CHANGE ORDER FORM

Change Order No.: 1

Name of Project: City Hall Parking Lot and Courtyard

RE: Fountain addition

DRAINAGE & WATER PLAN
SHEET NO. 3 OF 11

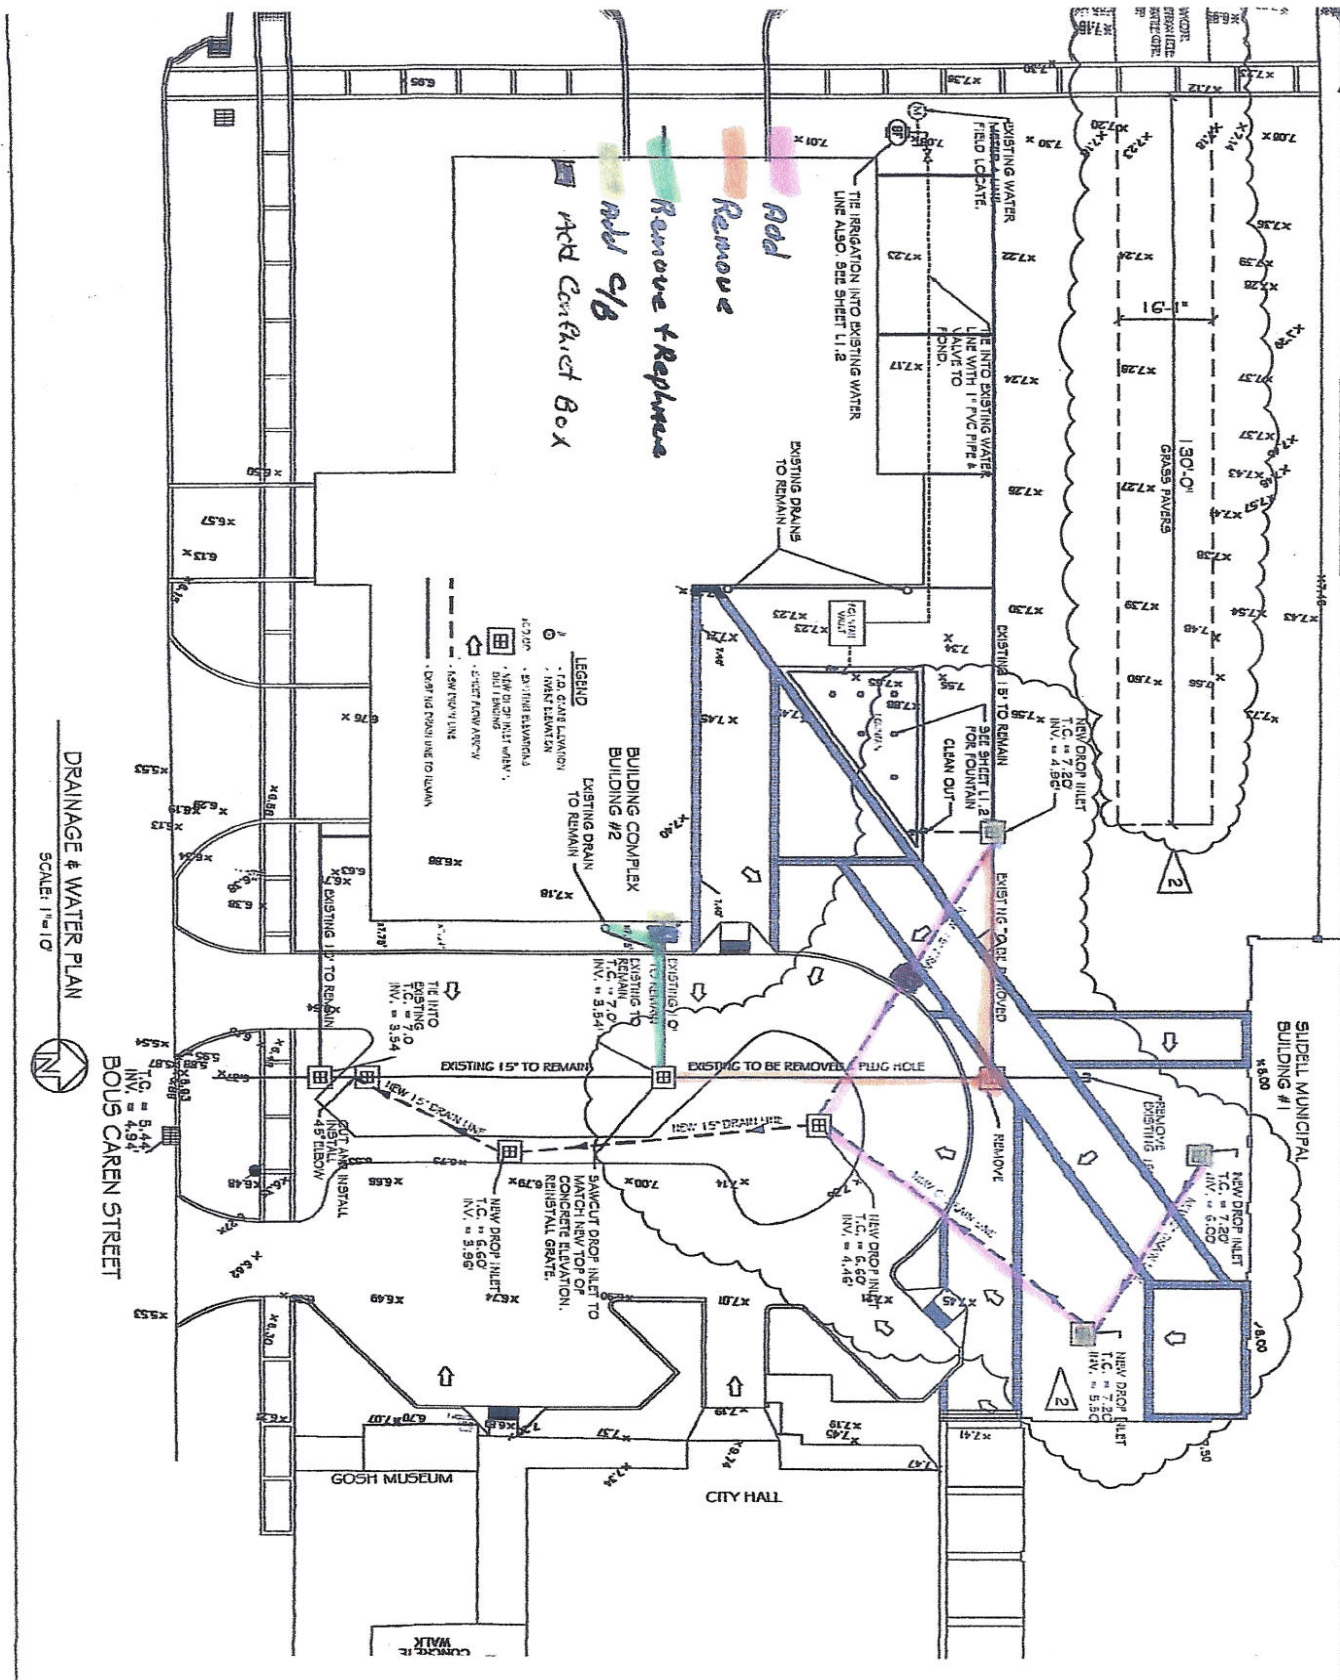
Justification for Changes: Redesign DRAINAGE, add curb, Pond

ARTISTIC CONCEPTION

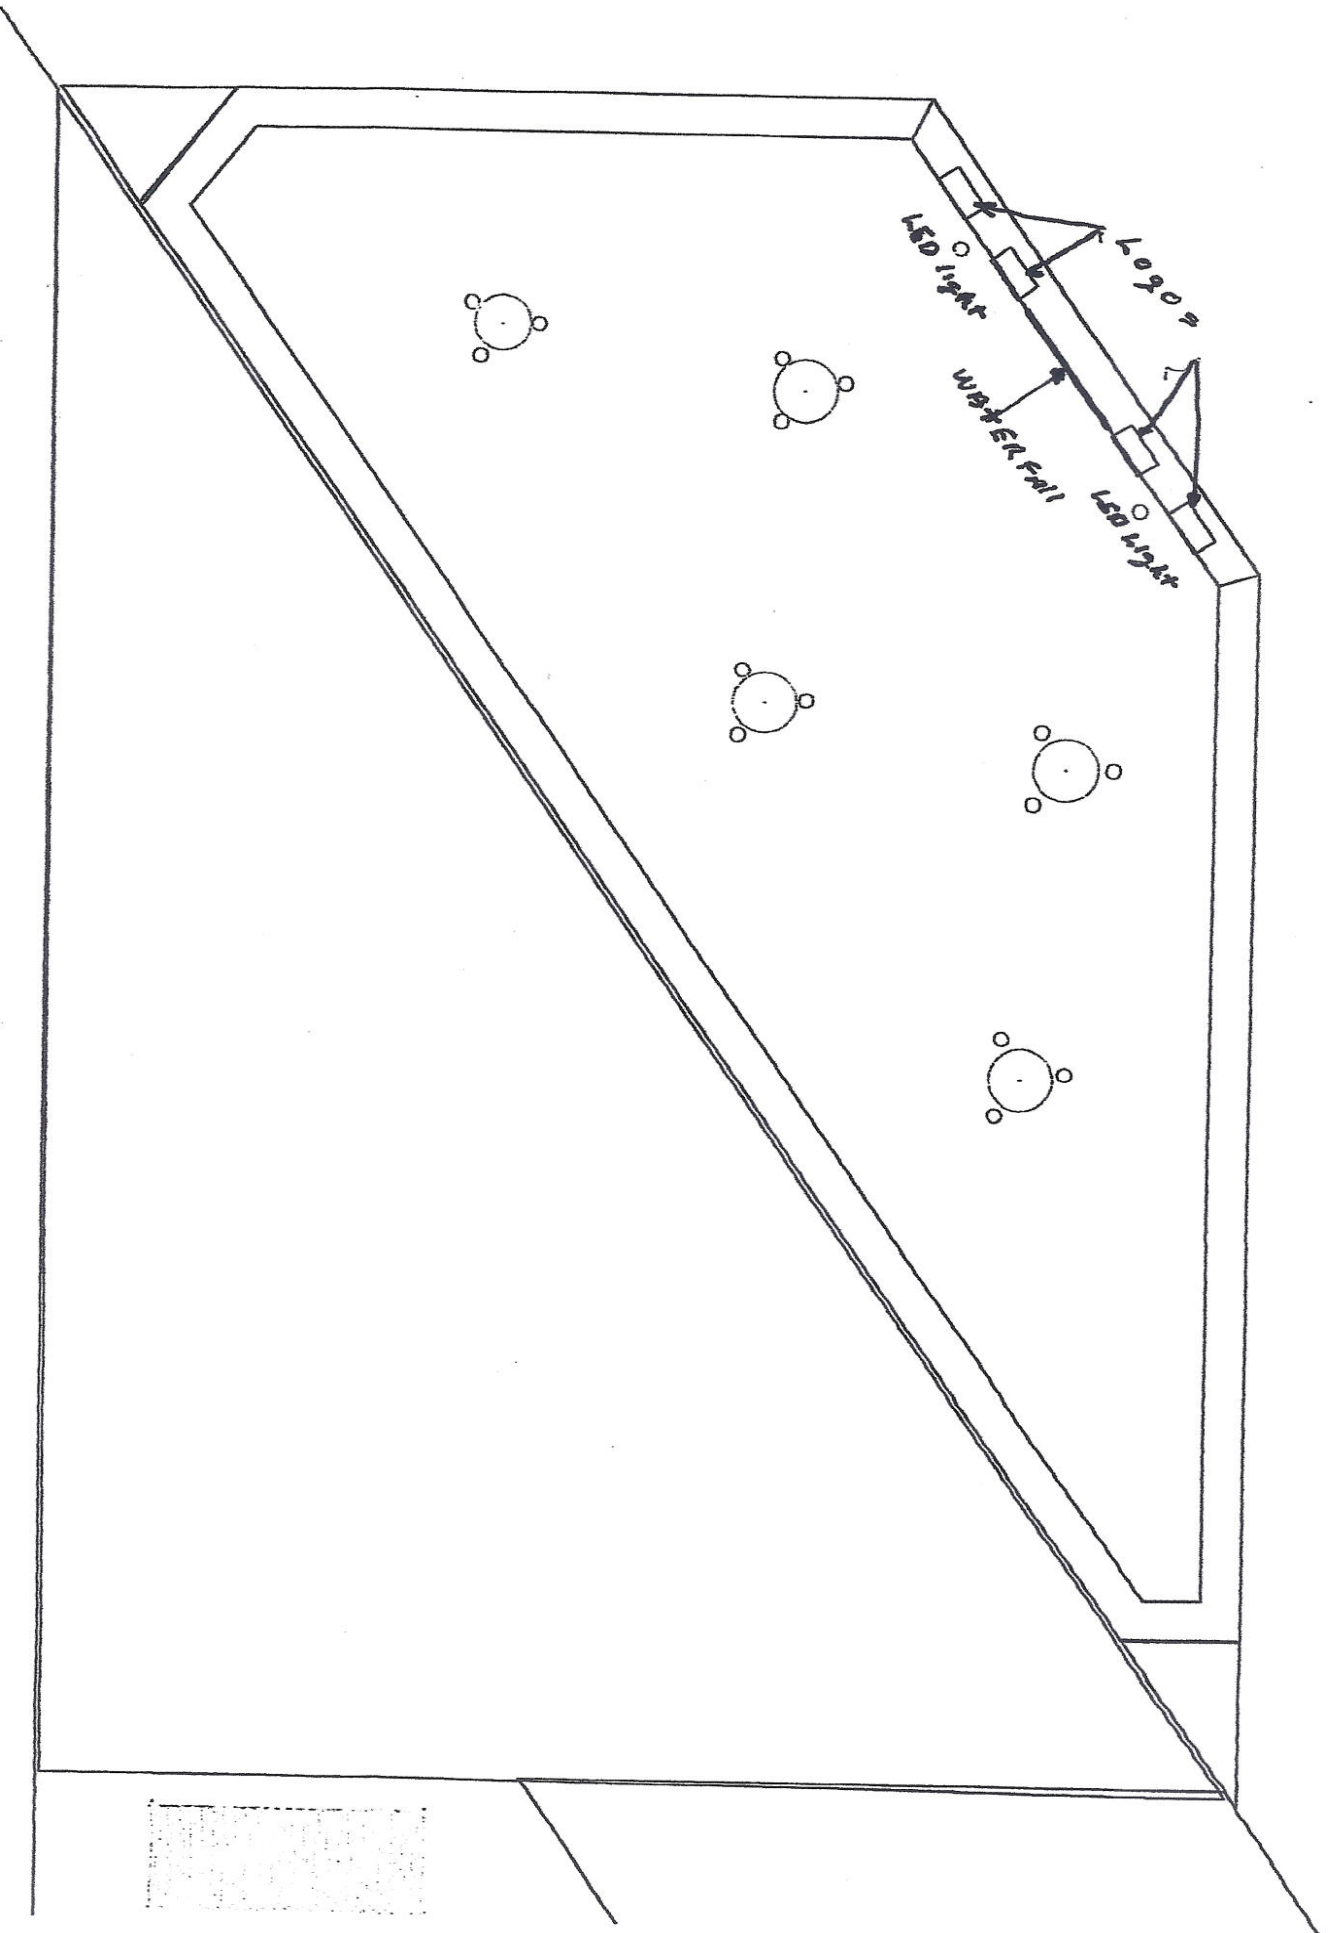
Build the fountain pool for City Hall Parking Lot and Courtyard as modified at meeting. The pool will have 2 skimmers, 2 return lines, 5 bubbler fountains with 3 LED lights each. The pool interior will be plastered with white plaster. The interior waterline to be faced with pool tile and all top surfaces covered with coordinating brick coping. A fountain wall approximately 12' long and 2' high faced with tile and including 4 ea. 12" x 12" "Logo" tiles and a 24" waterfall as per drawing. Each pair of "Logo" tiles will have one LED light to illuminate the wall. Overflow and water level control to be in the remaining corner. Outside vertical surface to be Stucco, color to be chosen.

The fountain equipment to consist of an upgrade to one energy efficient pump, Cartridge filter, Auto Chlorinator and Dual Timer (one for lights, one for pump), 1 control valve for each bubbler and the waterfall (6ea.), all to be installed in the "water sprinkler" room in the adjacent building.
